CITY OF MADISON

PLAN OF PROPOSED IMPROVEMENT

601 RAYOVAC DRIVE REDEVELOPMENT

CITY PROJECT NO. 11740

PLAN AND PROFILE

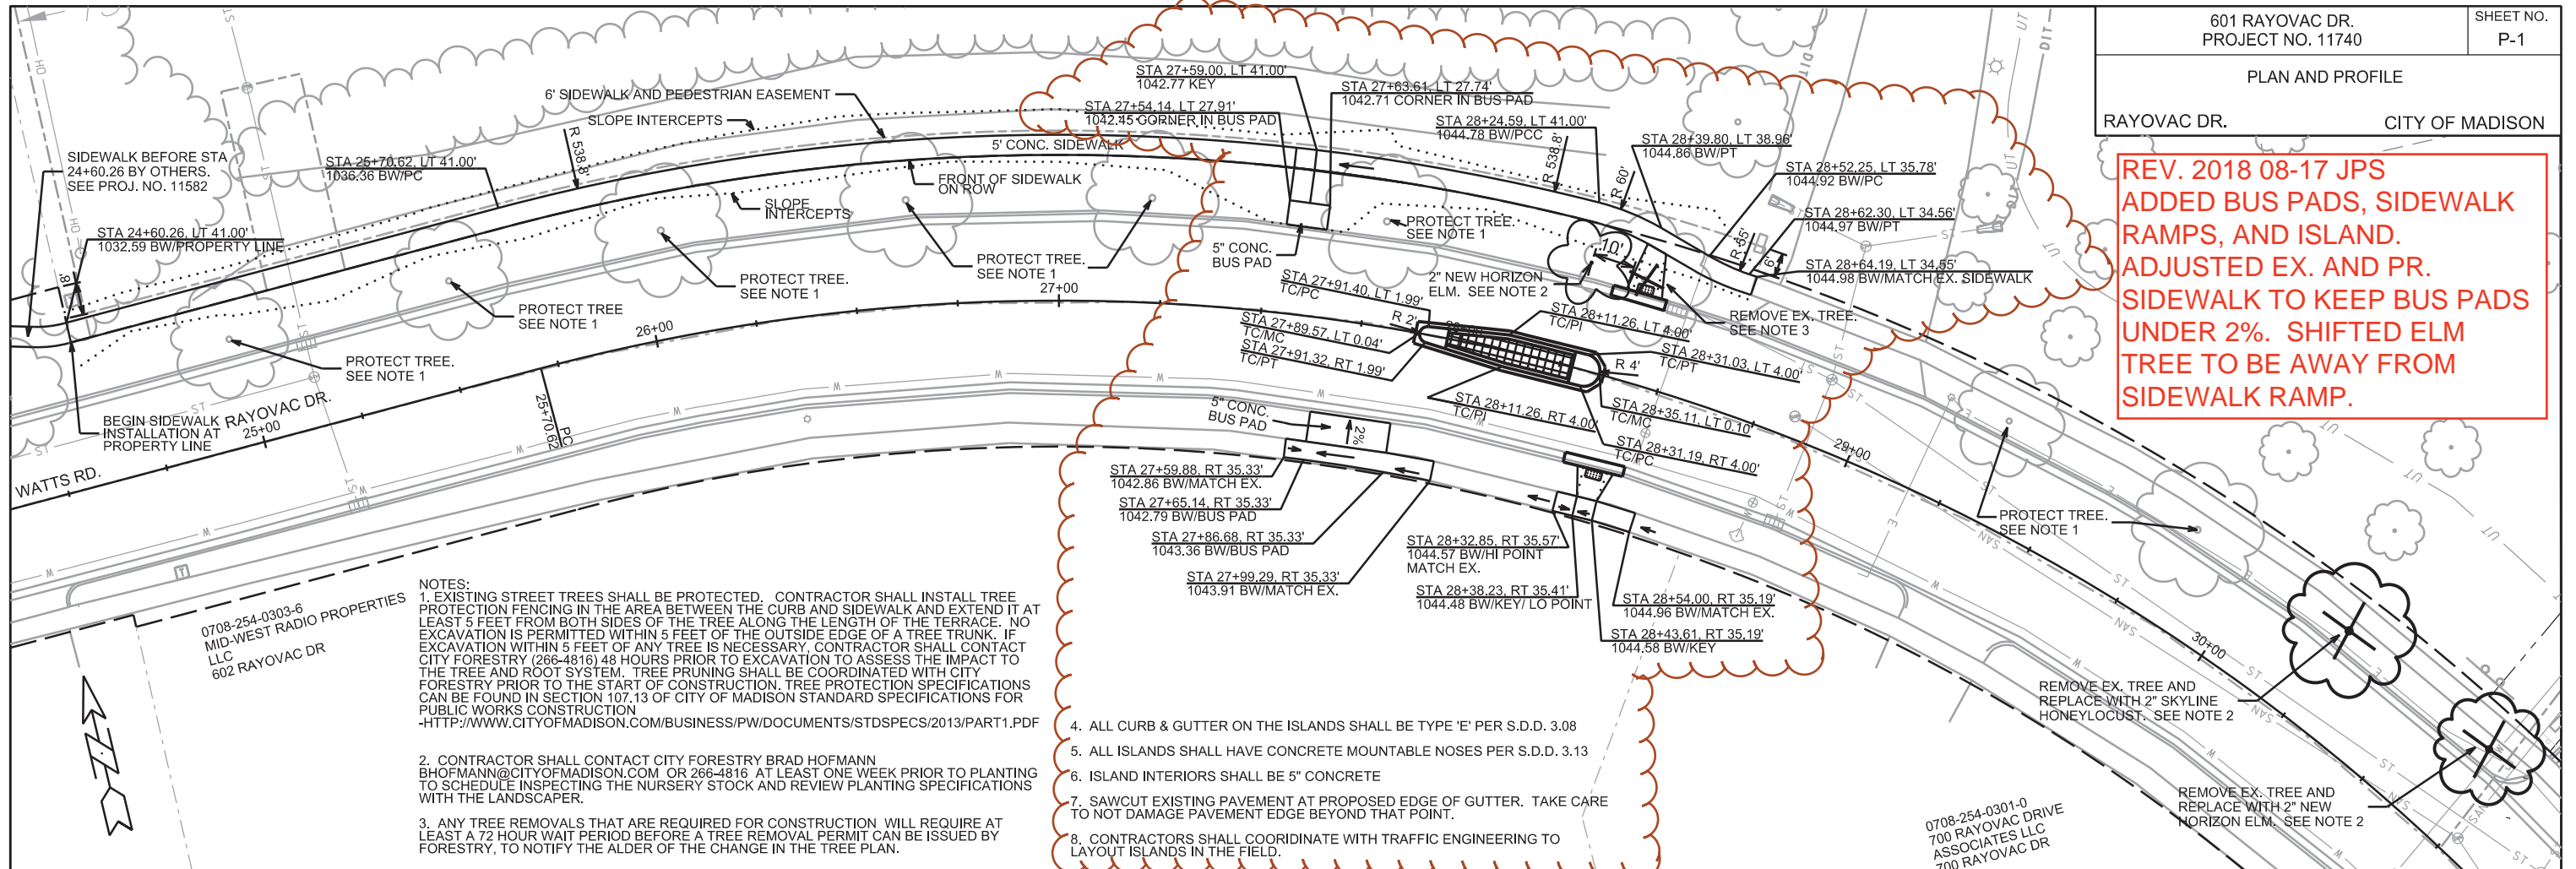
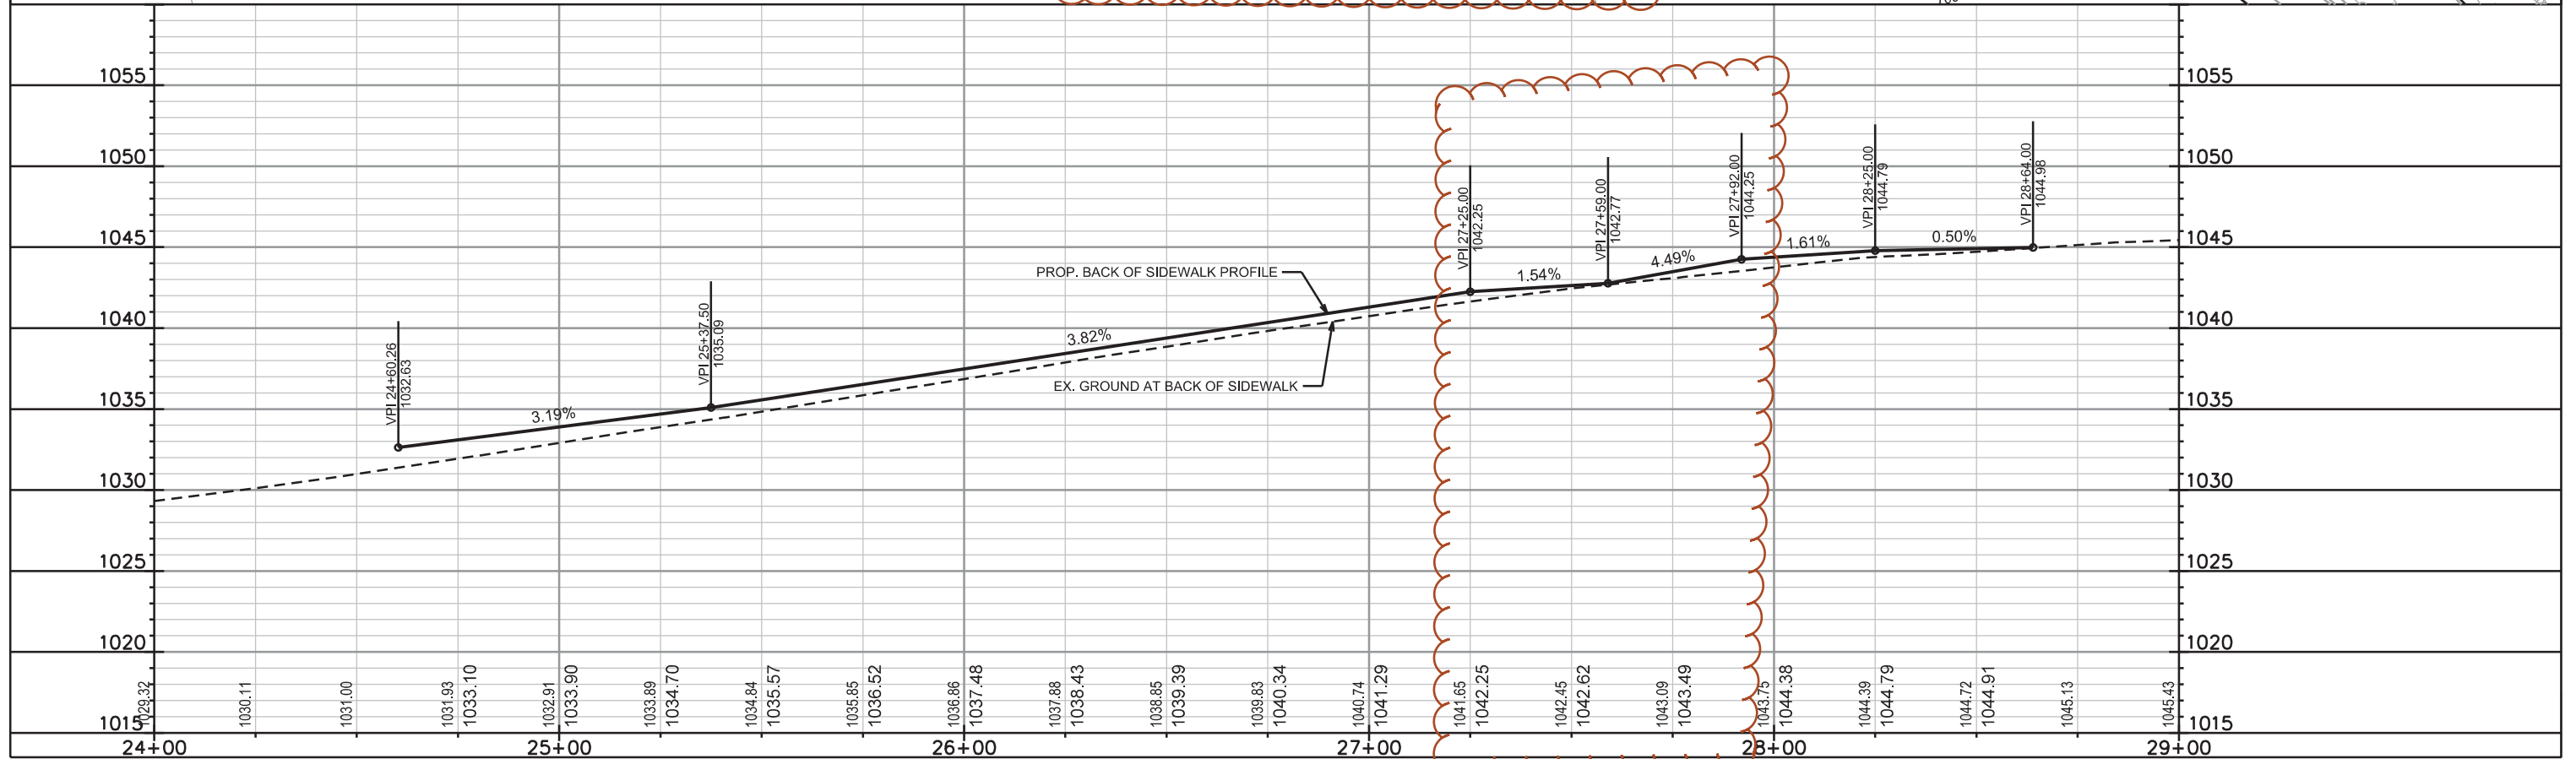
**REV. 2018 08-17 JPS
ADDED BUS PADS, SIDEWALK
RAMPS, AND ISLAND.
ADJUSTED EX. AND PR.
SIDEWALK TO KEEP BUS PADS
UNDER 2%. SHIFTED ELM
TREE TO BE AWAY FROM
SIDEWALK RAMP.**

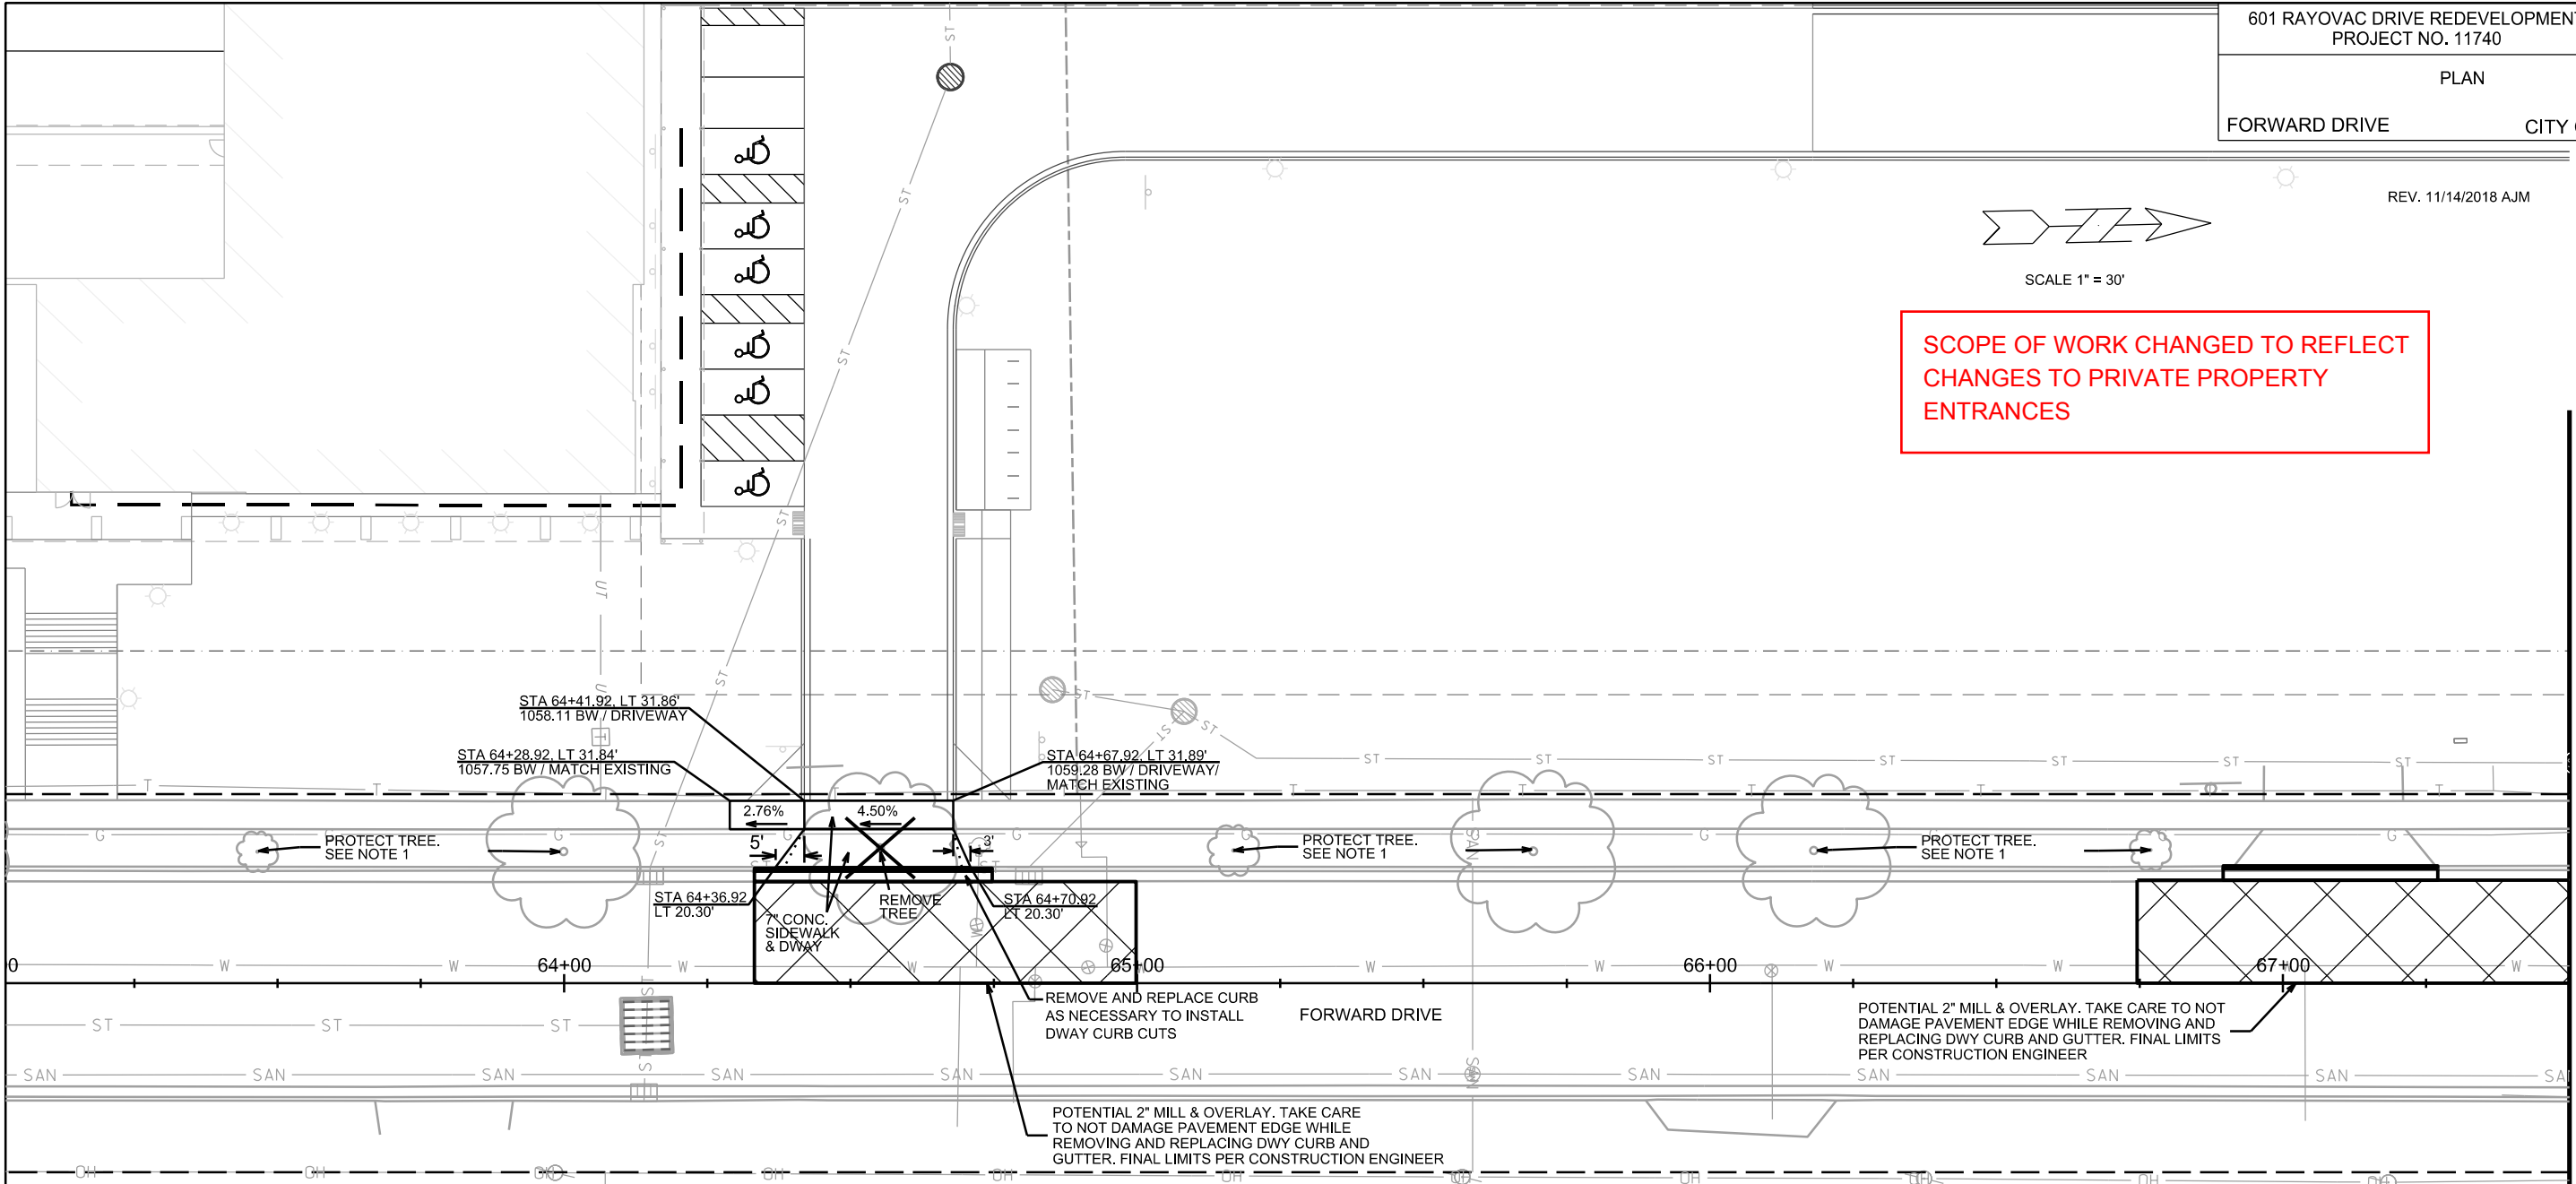
SCOPE OF WORK CHANGED TO REFLECT
CHANGES TO PRIVATE PROPERTY
ENTRANCES

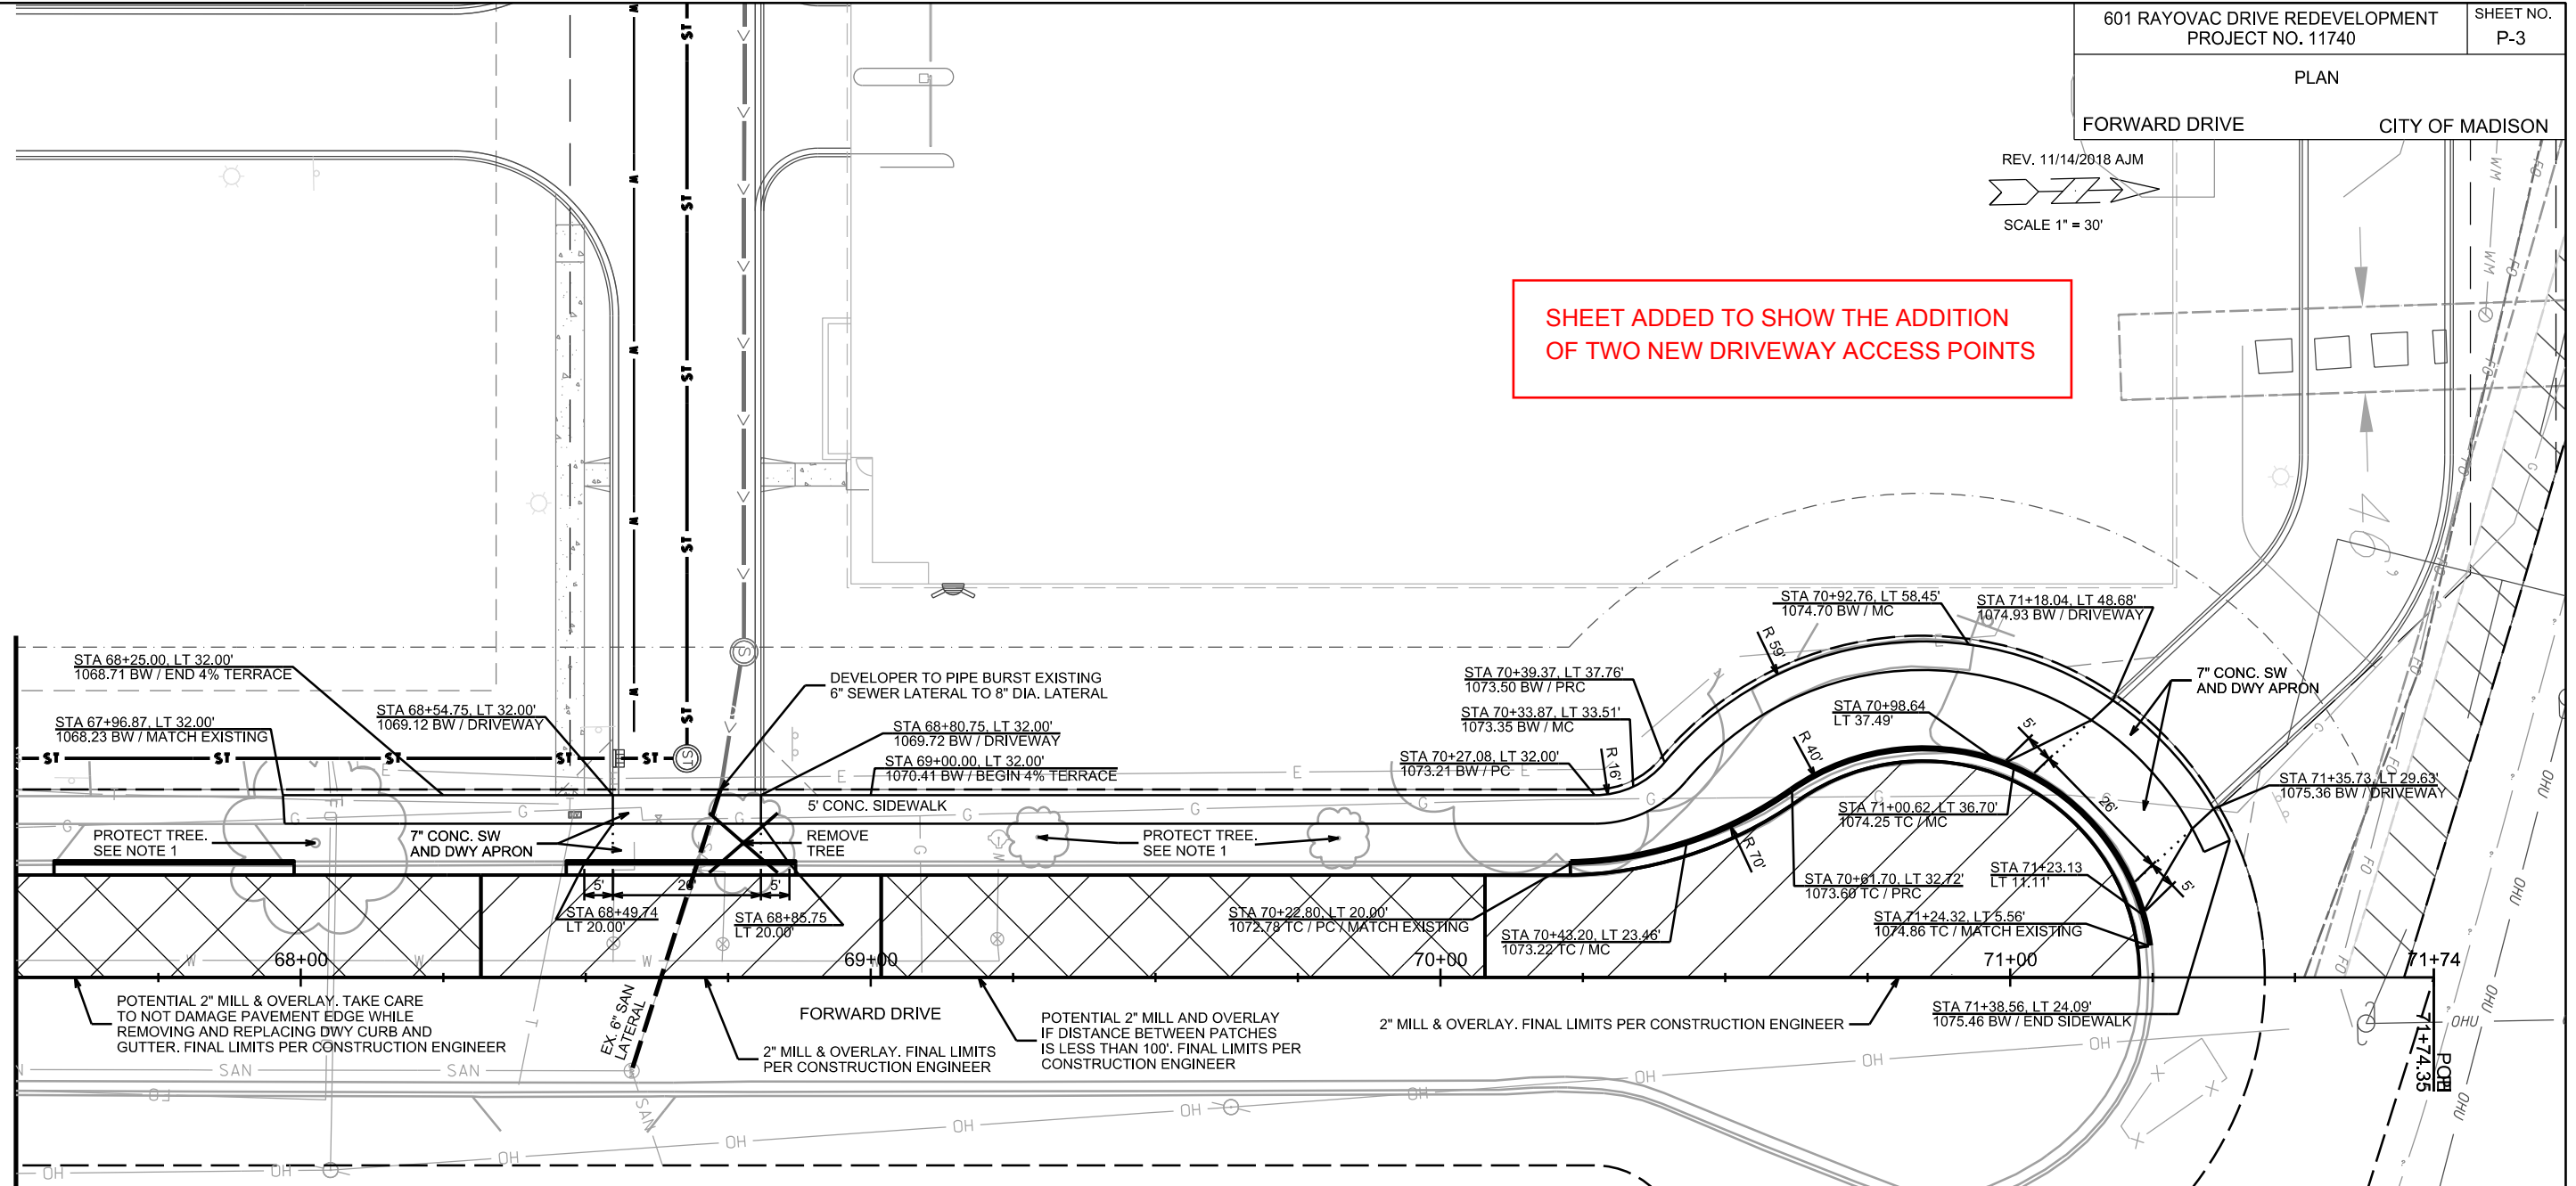
SHEET ADDED TO SHOW THE ADDITION
OF TWO NEW DRIVEWAY ACCESS POINTS
